**Subject: AP1000 COL Standard Technical Report Submittal of APP-GW-GLR-101, Revision 0**

**APP-GW-GLR-101, Revision 0**

**AP1000 Probabilistic Risk Assessment Site-Specific Considerations**

**Technical Report Number 101**

Figure 5.3-1: Pipeline Accident Model

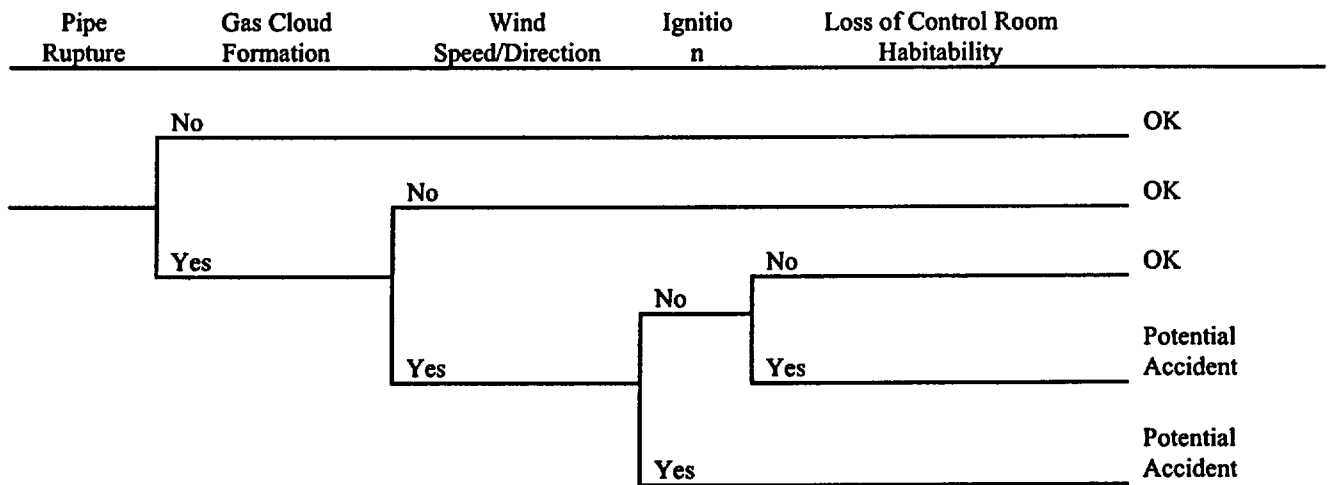
Consider Figure 5.3-1 to further evaluate the probability of this accident. When considering the pipe rupture frequency, the probability of forming a dense gas cloud, and the probability of the wind speed and direction to be in the ranges necessary to transport the gas cloud 5800 feet to the site, without dispersing the gas, including ignition of the gas cloud on-site in a location that may challenge the plant, this event probability becomes very low.

Consider Figure 19.58.2.3.3-1 to further evaluate the probability of this accident. When then considering the probability of forming a dense gas cloud, and the probability of the wind speed and direction to be in the ranges necessary to transport the gas cloud 5800 feet to the site, without dispersing the gas, including ignition of the gas cloud on-site in a location that may challenge the plant, this probability becomes very low.

Figure 19.59-2

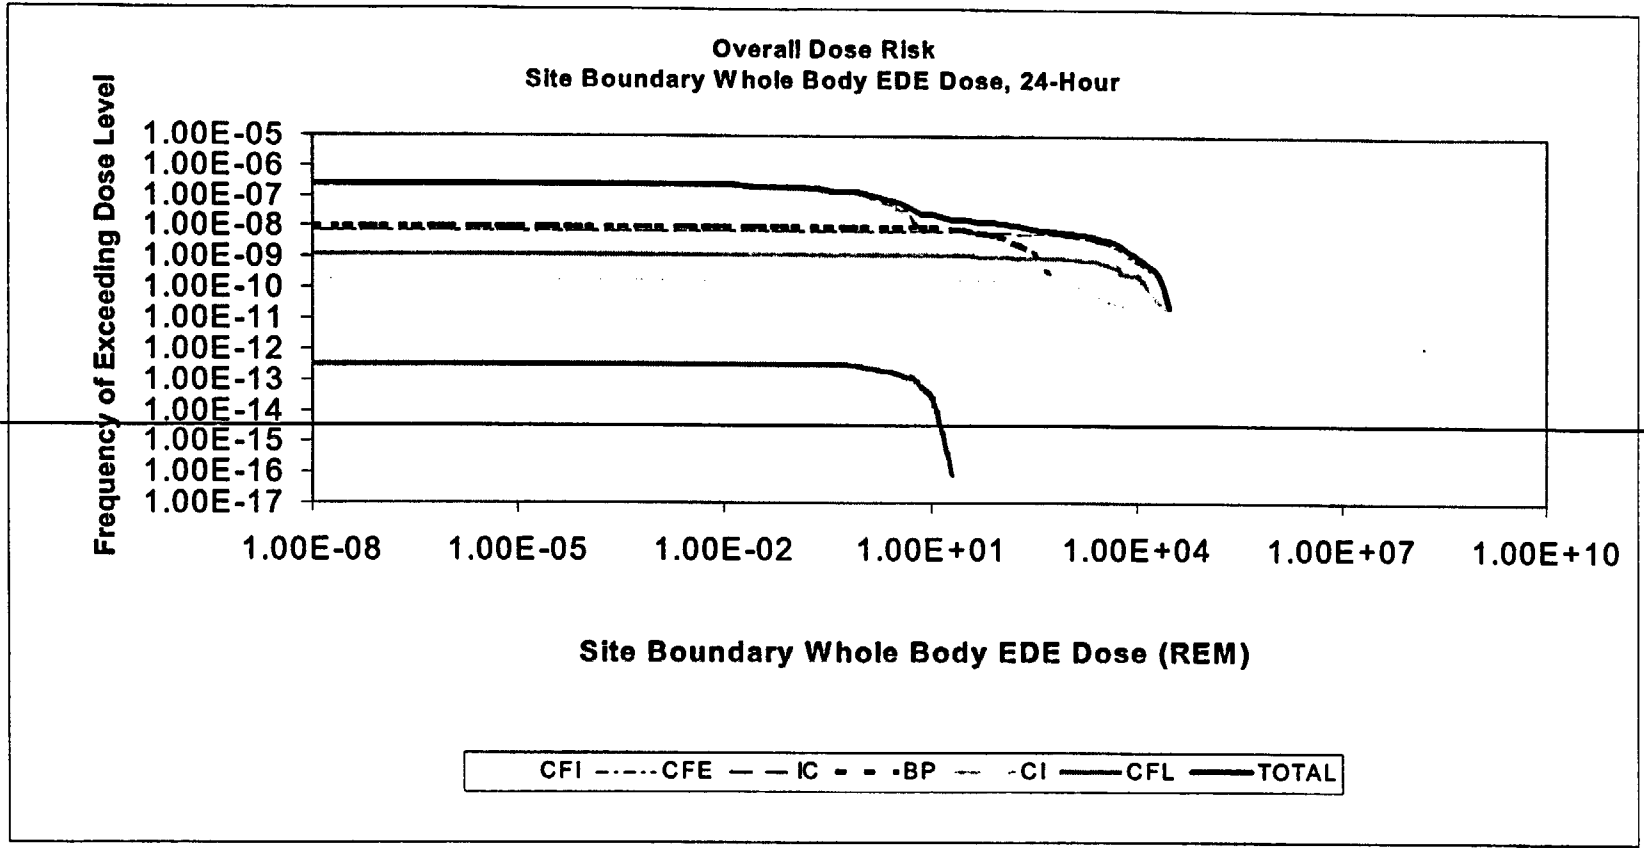
~~Figure 19.59-2 shows the 24 hour, whole body EDE site boundary dose cumulative distribution.~~

Delete Figure 19.59-2:
